Amhurst Elevated Storage Tank Rehabilitation Project - RFCSP
Solicitation No.: CO-00505
SAWS No.: 21-0128

ADDENDUM 2
March 4, 2021

1
C-10
TYP. 5' CHAIN LINK FENCE DETAIL
NTS

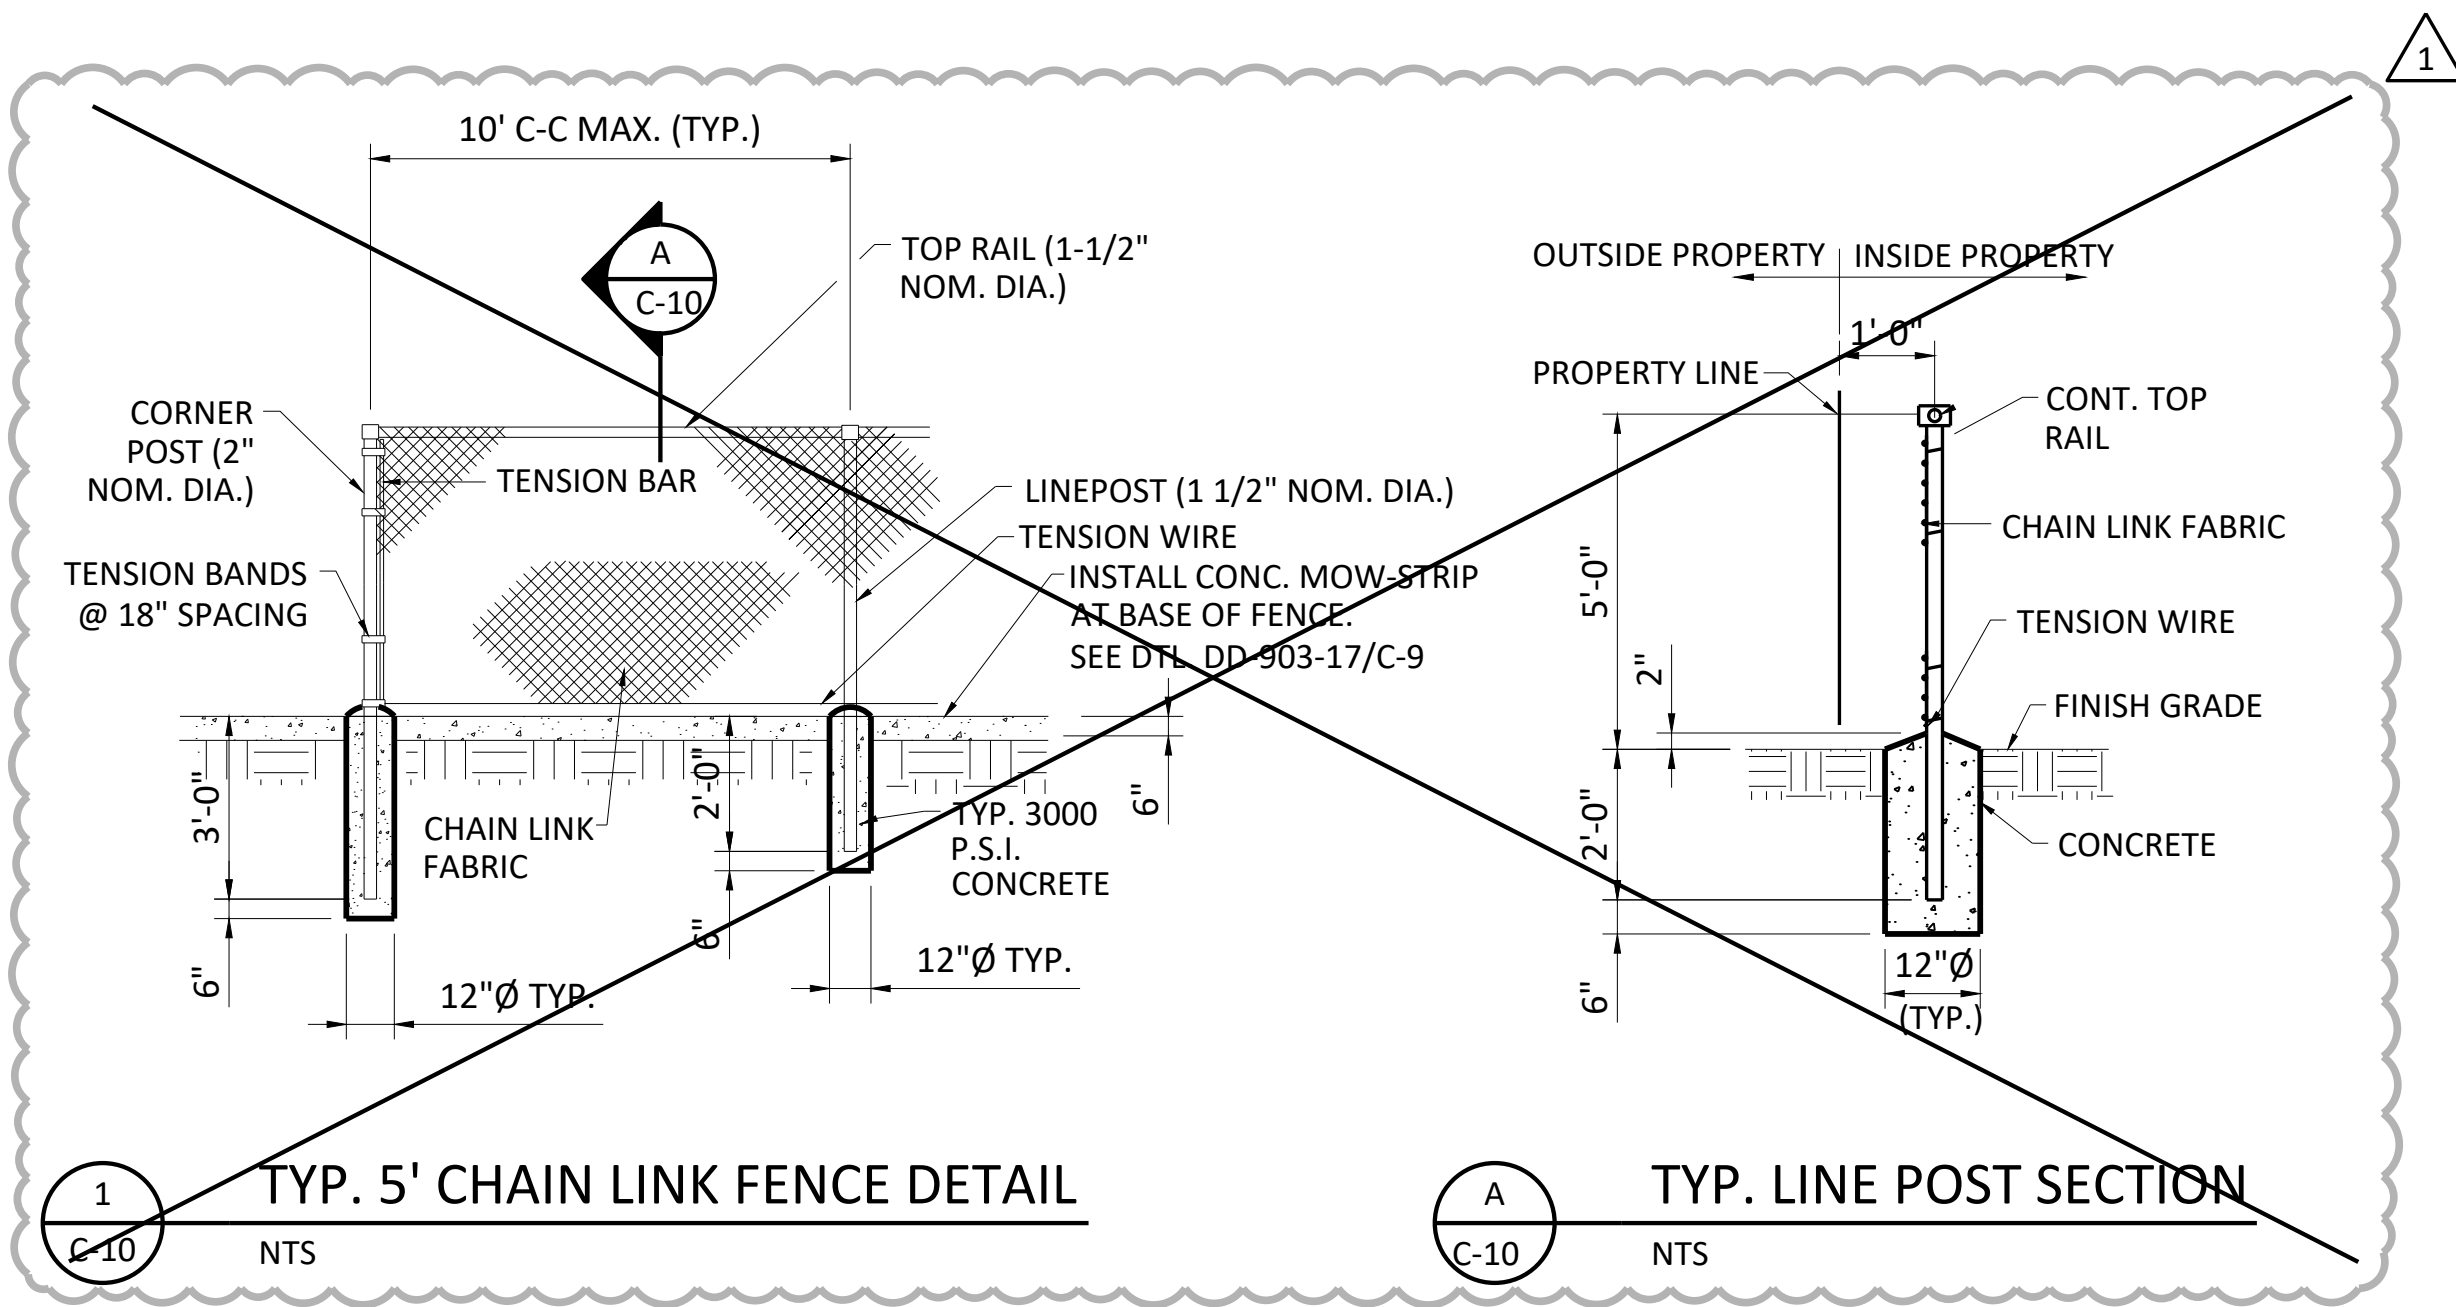
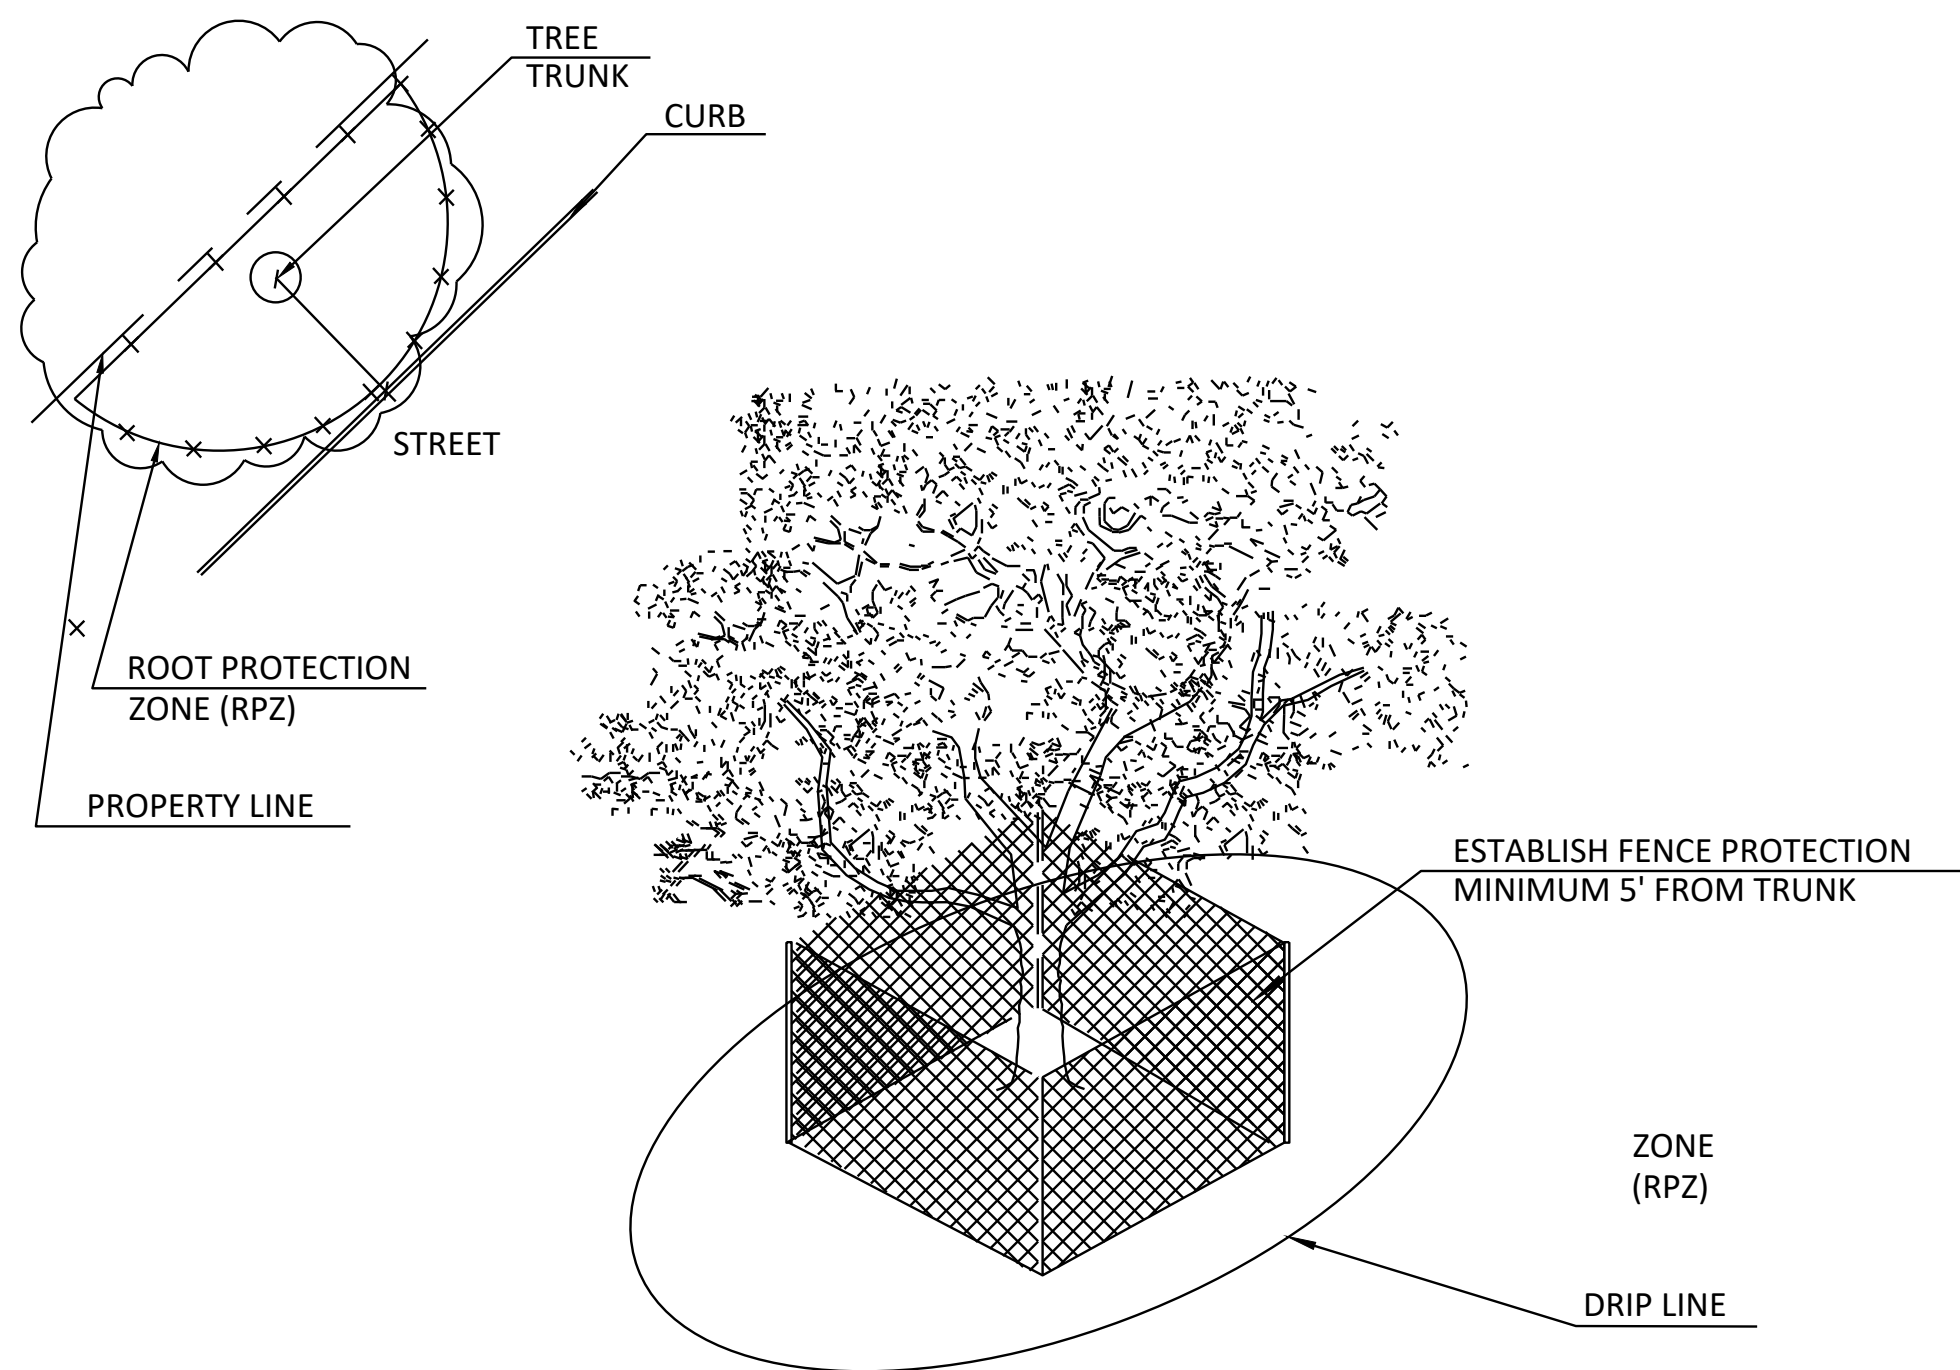
NO.	ISSUE	BY	DATE	DESIGNED	DRAWN	REVISIONS	CHECKED	CAK
				RWR	RWR	EWL		
ADDENDUM NO. 2	FENCE REVISIONS	RWR	03/04/22					
VERIFY SCALE	Bar is one inch on original drawing. If not one inch on this sheet, adjust scale.							
0								
SHEET								
C-10								
SEQ.
